GENERAL

This addendum documents a change to the Receiver IF Module (19D902783G7 & G11) Maintenance Manual. Torque specification changed from 20 in-lbs. to 12.5 ± 2.50 in-lbs.

This addendum updates the Assembly Diagram for Receiver IF Module 19D902783G7 & G11 in Maintenance Manual LBI-39123.

21.4 MHz RECEIVER IF MODULE
12.5/25 kHz CHANNEL SPACING
19D902783G7 & G11

(19D902783, Rev. 6)

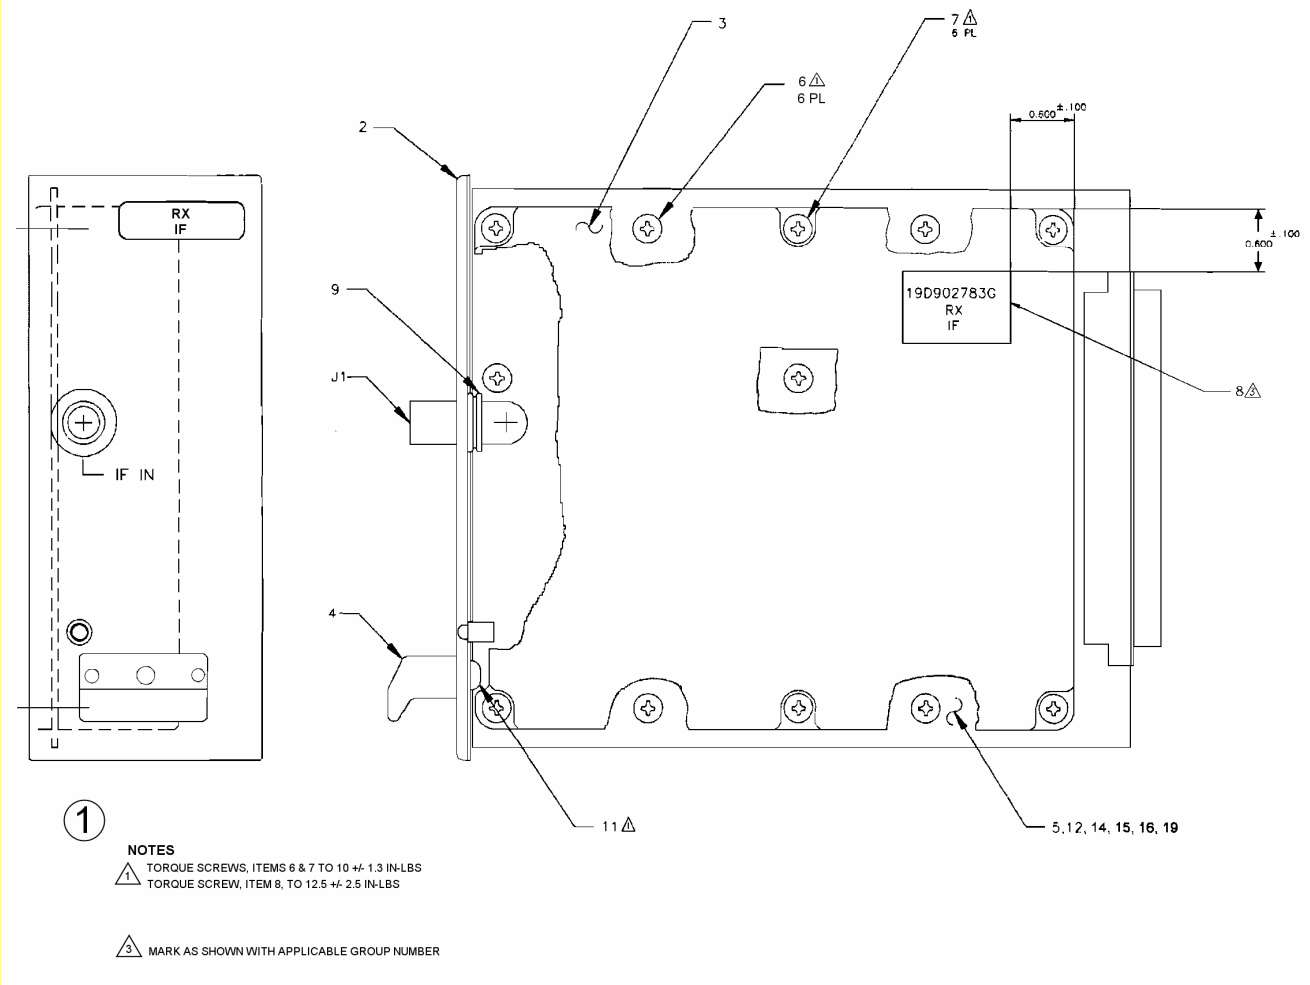
On page 10, update drawing 19D902783 with revision 6.
